EXAMPLE #1

PROJECT MANAGEMENT - PUBLIC SERVICES - CITY OF ANN ARBOR	
UNIVERSITY OF MICHIGAN WILLIAM L. CLEMENTS LIBRARY INFRASTRUCTURE IMPROVEMENTS AND ADDITION UM PROJECT NUMBER: P00001692 RIGHT OF WAY GRADING PLAN	
SCALE HORIZ. 1"=20' VERT. 1"=2'	INCH 0 1
DRAWING NO.	CG1.1
SHEET NO.	OF

PRELIMINARY SITE PLAN REVIEW

UM AEC Proj No #: P00008399;

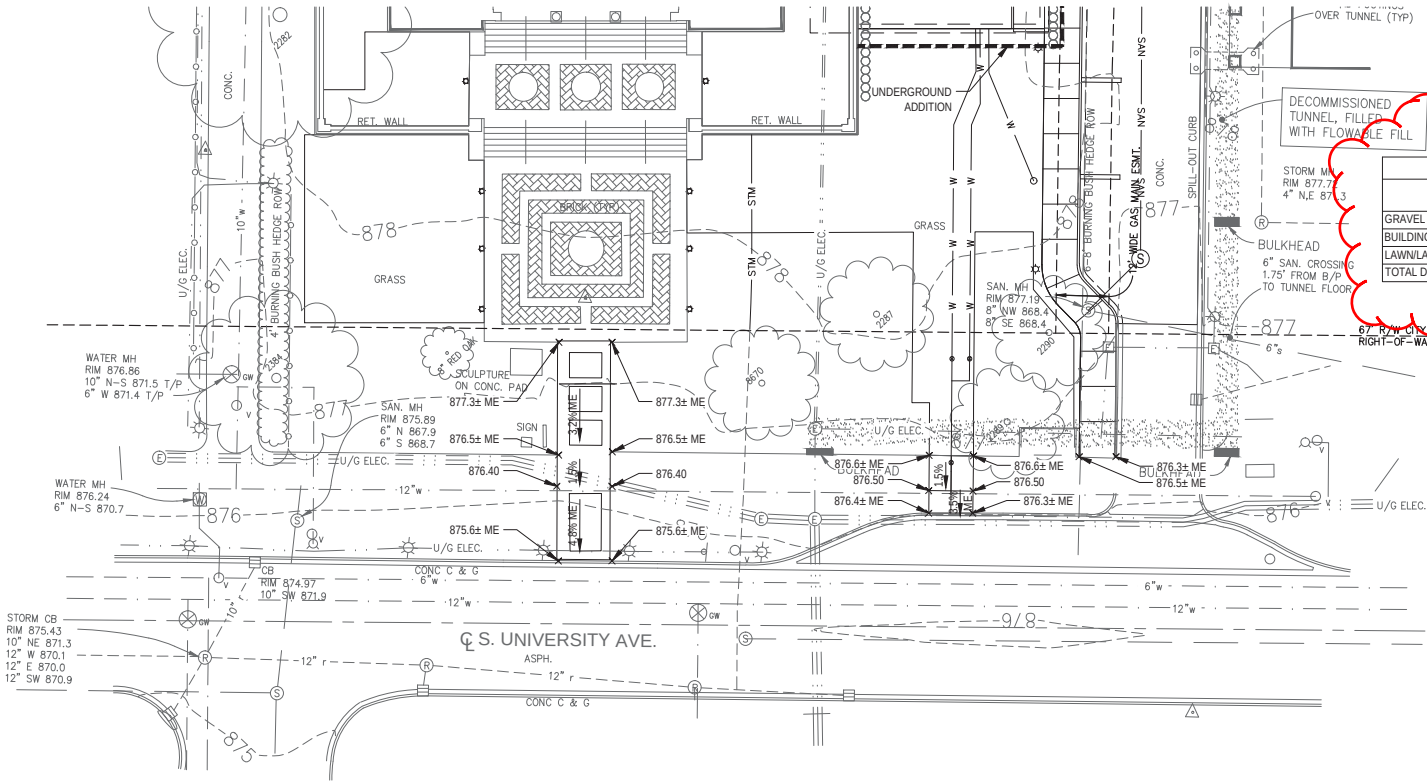
Show chart of with change in impervious -see attached example chart. Increase in impervious must be reviewed/approved by U-M Campus Planning and project team may be directed to design additional storm water management BMPs.

Provide a list of elective storm water BMP's to be installed and quantify benefits, if feasible.

Include the language: "Construction and operation of the storm water (infiltration/detention pond) or (BMP's on the plans) is/are in compliance with the requirements of State and Federal water pollution control laws."

Replace chart with format matching example chart below

C104C

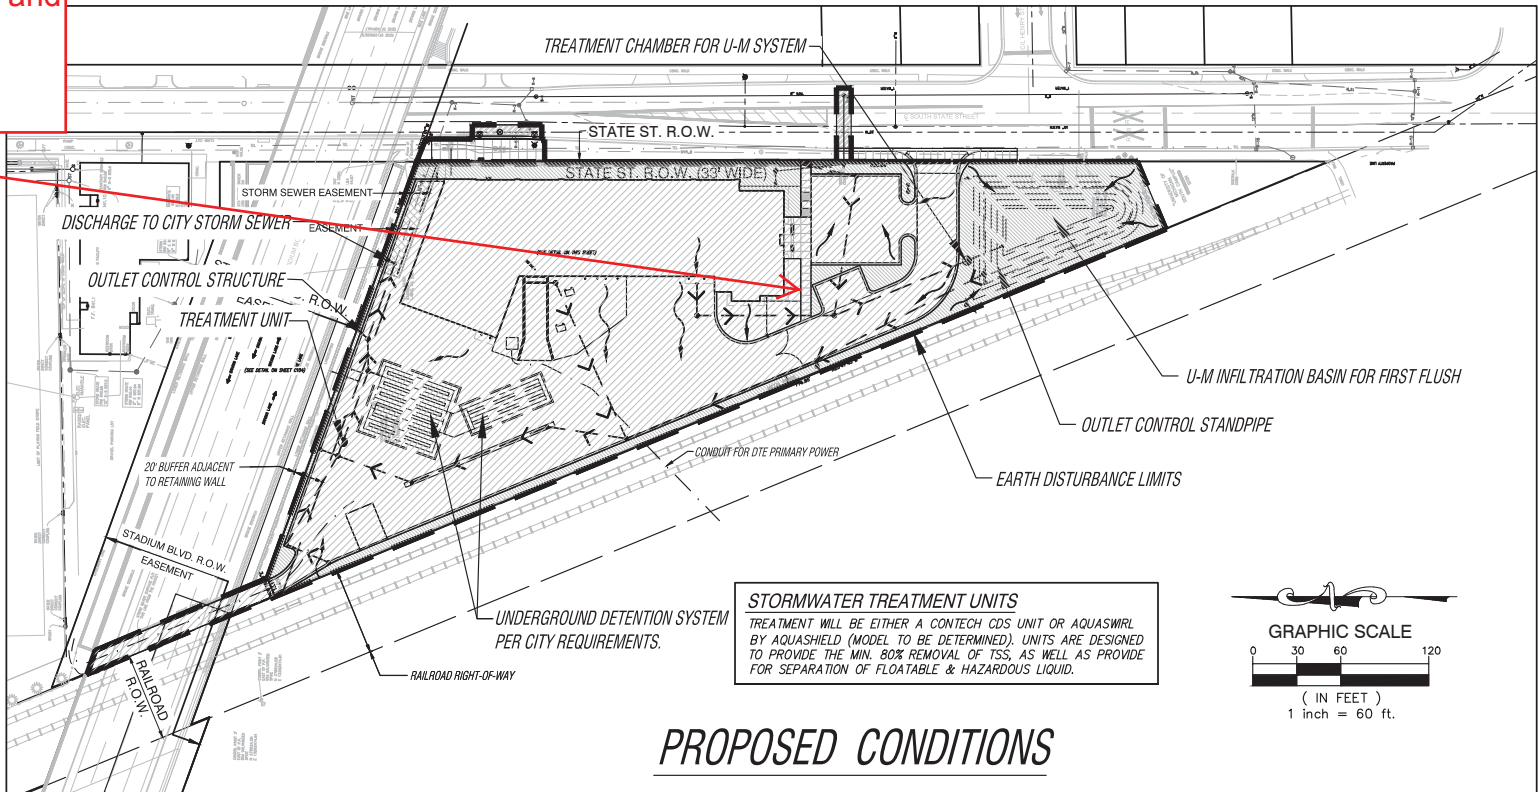
Adjust this graphic to provide hatching of surface based on imperviousness and remove site paving details

- Storm water sheet.
- Show drainage patterns of proposed and existing conditions with different hatching based on imperviousness. (See Campus Planning level of detail provided on U-M property)
- Provide narrative summarizing storm water as noted below.

C104AC

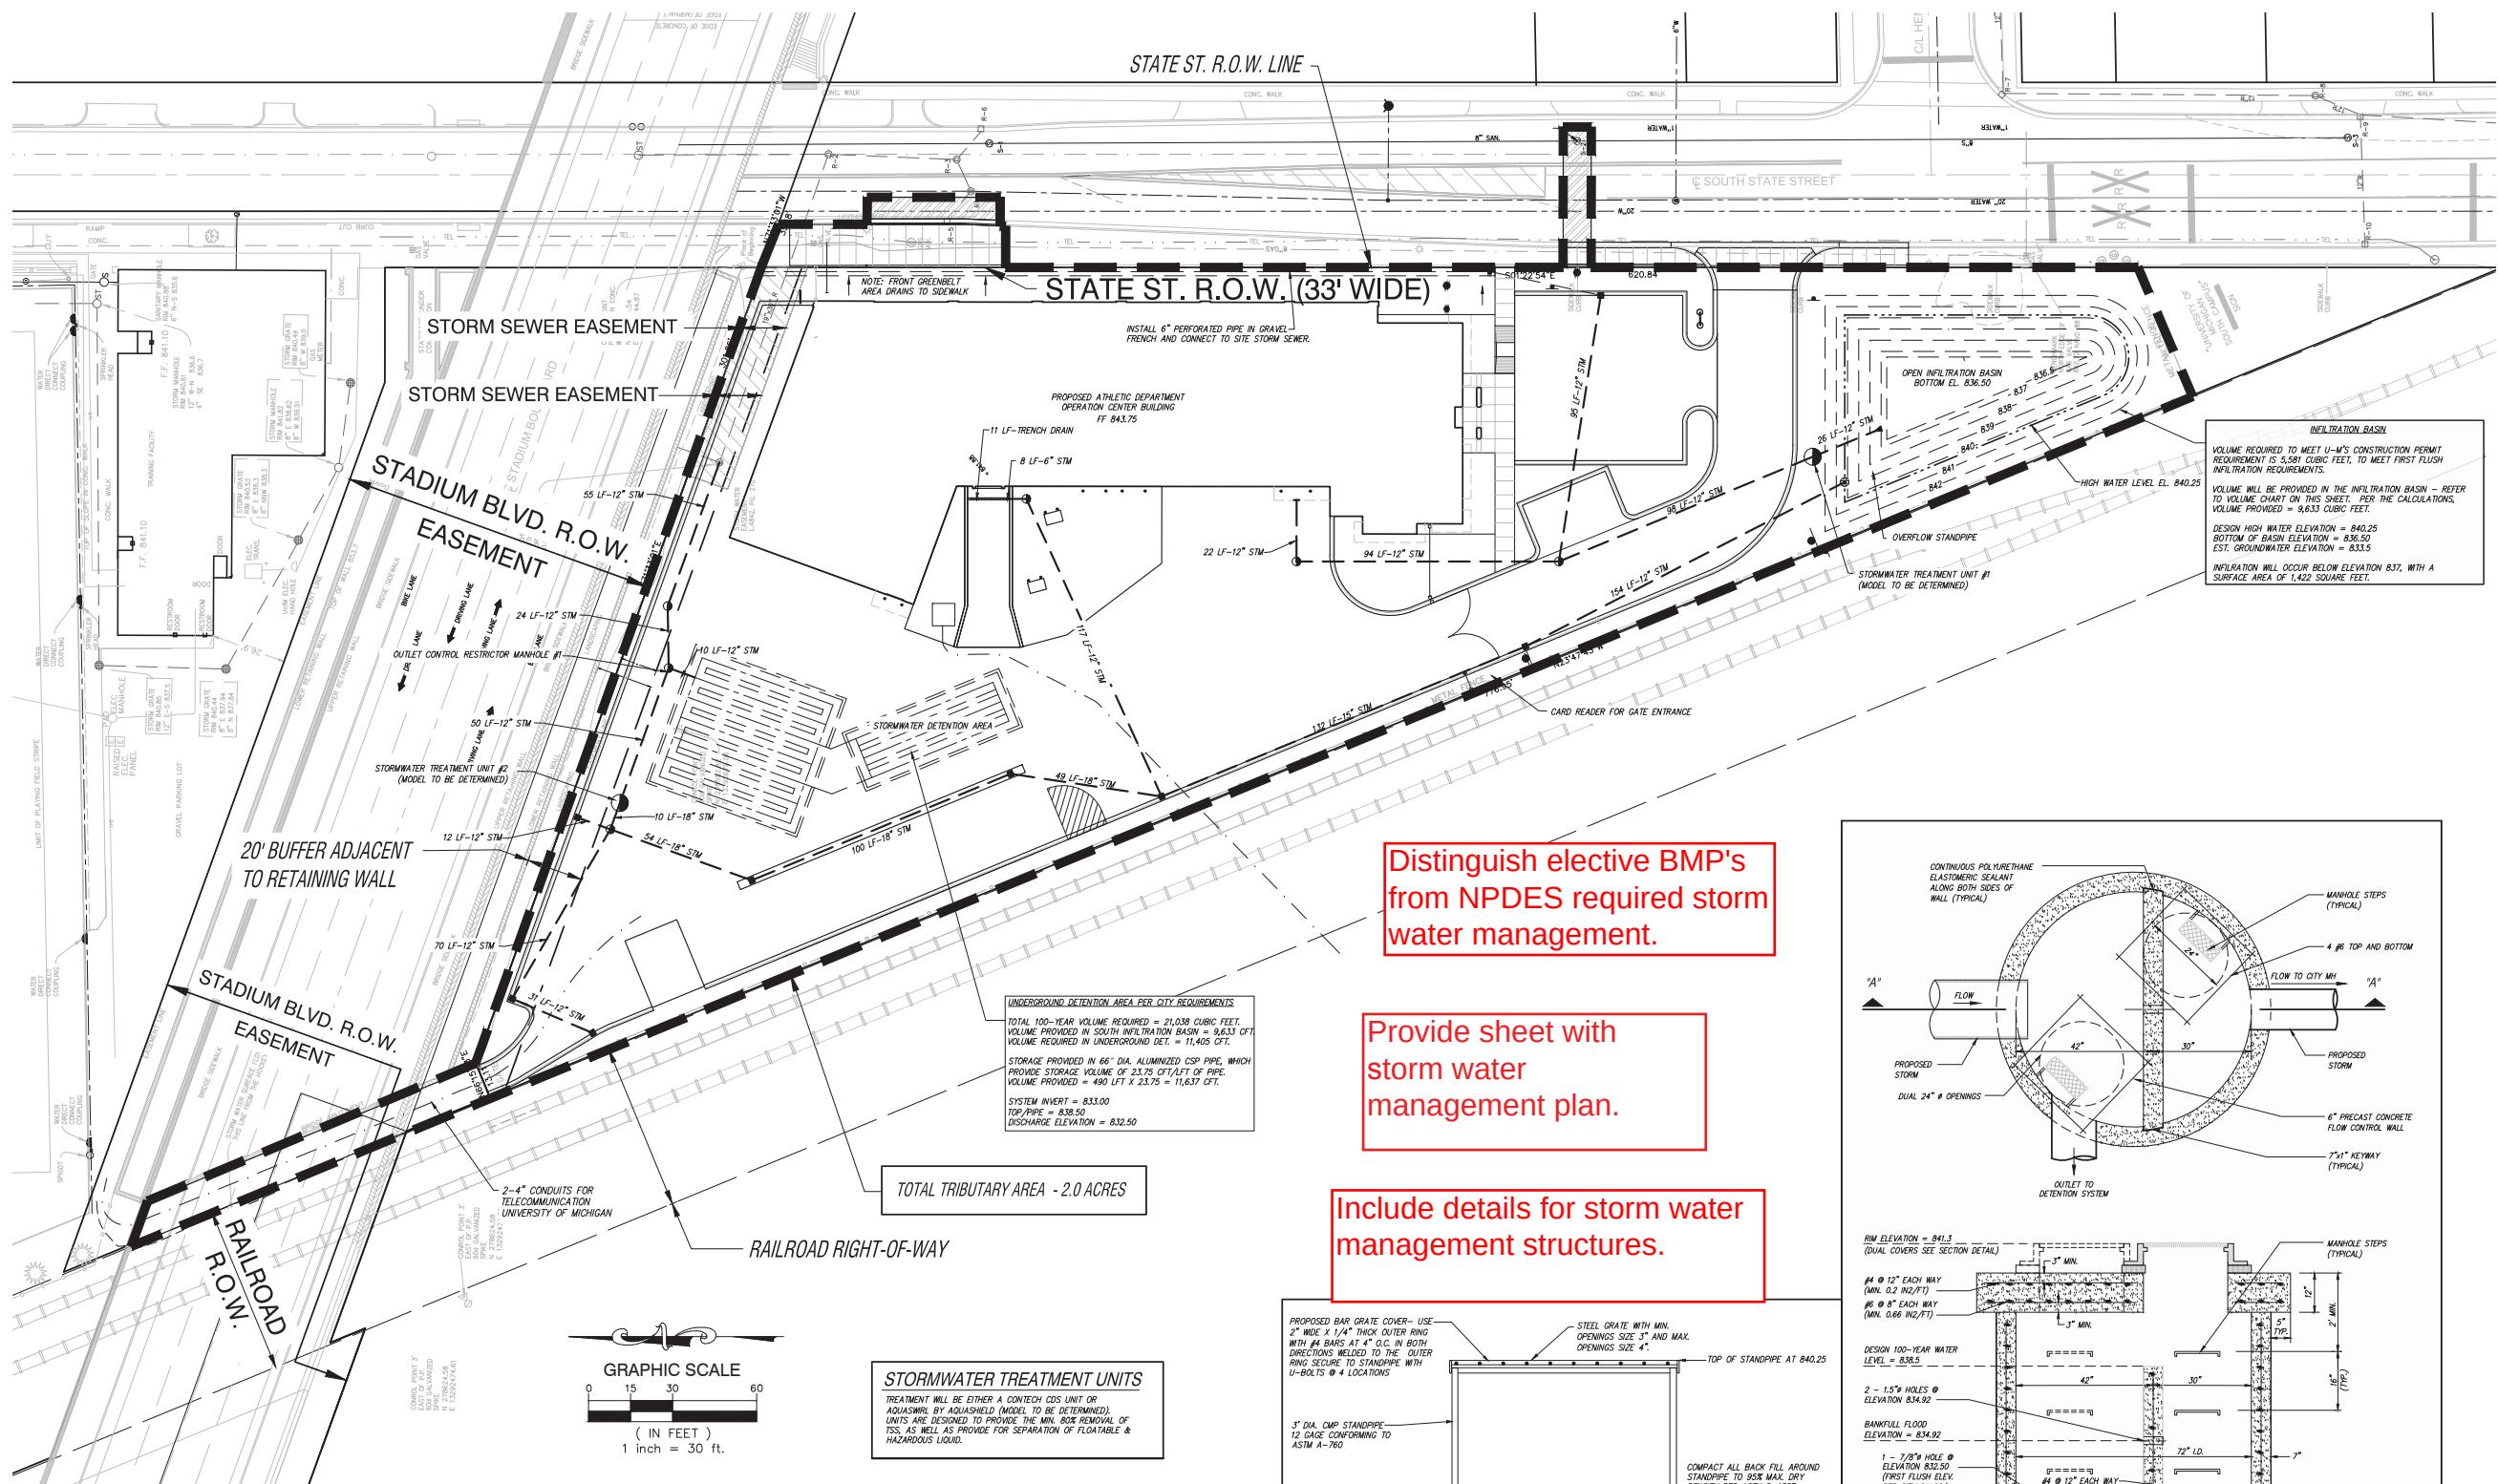
Distinguish elective BMP's from NPDES required storm water management.

Provide sheet with storm water management plan.

Include details for storm water management structures.
